**Geomorphological Considerations for the
Introduction of Boulders and
Groynes for Fisheries Enhancement:**

Assessment of R. Eden at Carhead.

Secondly the potential introduction of such features is assessed, with reference to the proposed works at Carhead on the Eden, (in the area of NY 37055864). The site evaluation is based on the findings of a field visit made by Jim Walker with Liz Oliver and Ted Luckley on 2.3.1998, and on the drawings presented by the applicants, prepared by Harrison and Hetherington Ltd.

Figure 1: Scour patterns using different boulder placements, (adapted from Cowx and Welcomme, *Rehabilitation of Rivers for Fish*, FAO, 1998, p.127).

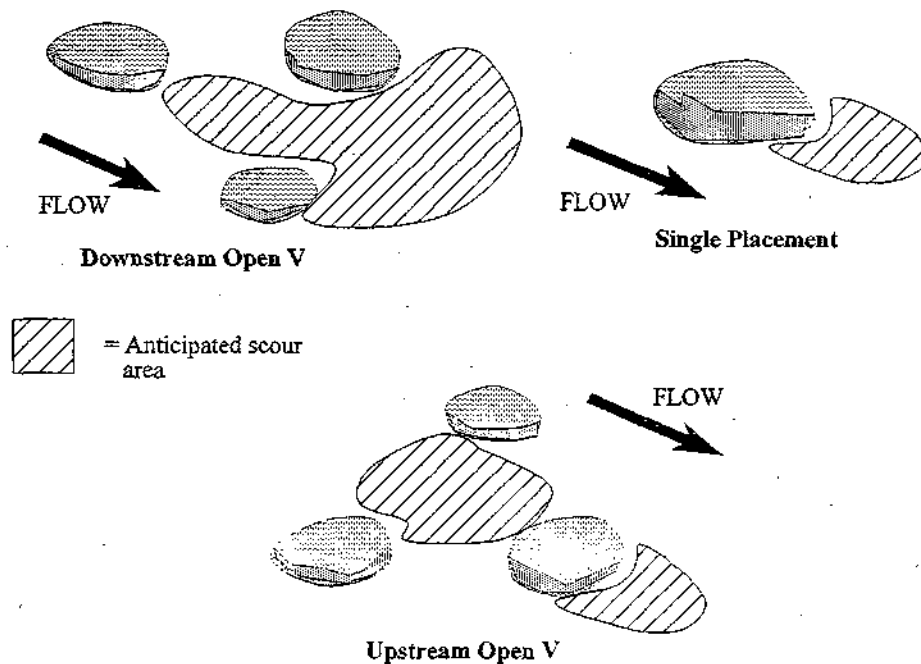
2.3.4	Suggested variation of proposed placement scheme to include 'downstream open V's' and single placements.
2.3.5	Suggested use of rounded boulders.
2.4.1	None Visible.

- Mid channel introduction should be used as per design drawings.
- Boulders used should be > 100kg. and have a non-angular rounded shape.
- Type of stone used should be from a local source of the same geological type as the natural bedrock which outcrops at the bed in the site reach.
- Boulders should be buried one third of their depth into the bed.
- The standing height of boulders, (height above bed), should not exceed 350mm.
- A range of 'upstream open V', 'downstream open V' and single placements should be used (as shown in figure 1), as opposed to the design proposals of downstream open V placement for all groups.

Figure 3: Suggested variations to drawing 3 design proposals, 'Groynes 1 & 2 generic plan'.

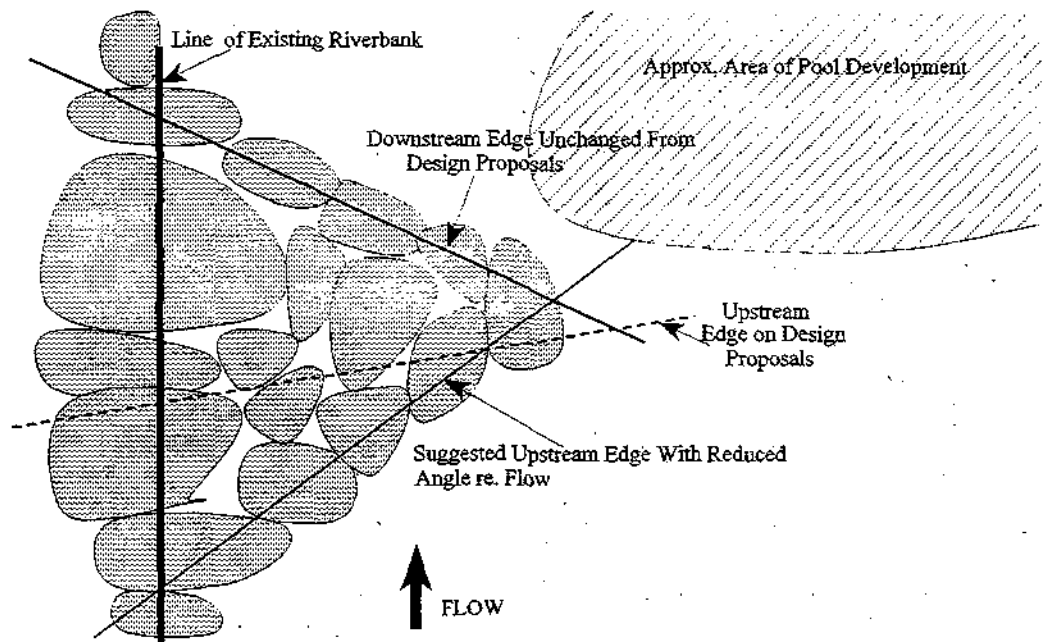
3.2.1	Stone type not specified.
3.3.1	Wing-shaped deflector design.
3.3.2	Upstream face is near perpendicular to the flow, recommend that this angle is reduced.

- Groynes designed are strictly speaking deflectors.
- Structures should use stone from a local source of the same geological type as the natural bedrock which outcrops at the bed in the site reach.
- Individual stones used in construction should be minimum 100kg, and those that form the outside of the structures should preferably have rounded edges.
- Shape of structure should be slightly redesigned to give a softer angled upstream edge, (see figure 3 below).

Figure 4: Suggested adaptation of drawing 3 design proposals 'groyne 2'.

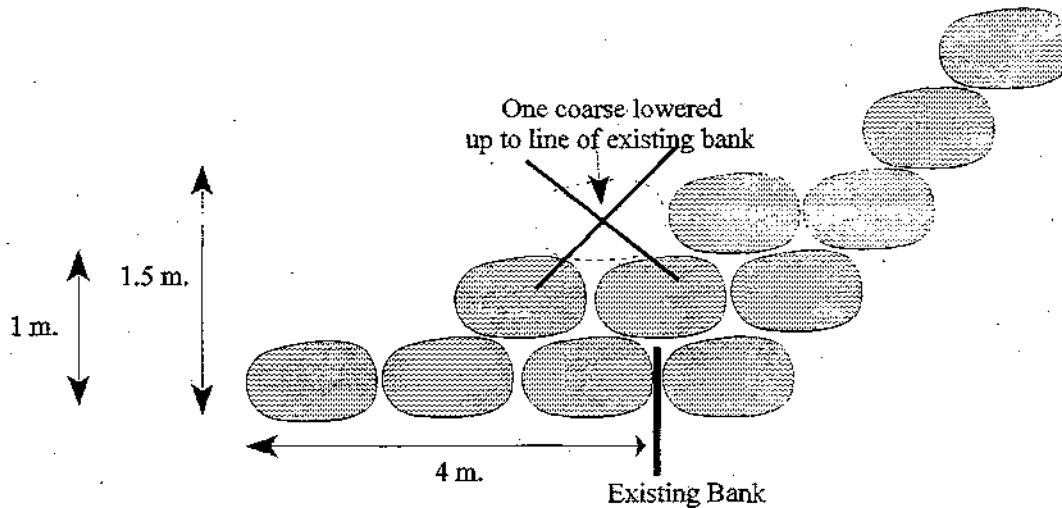
3.3.5	Level = 1 metre and 1.5 metres at 'groynes 1 & 2'. Suggested that upper course is removed from groyne 2 up to line of existing bank level, reducing level to approx. one third bankfull height.

- Suggested that upper coarse is removed from groyne 2 up to line of existing bank level, reducing level to approx. one third bankfull height. (See figure 4).
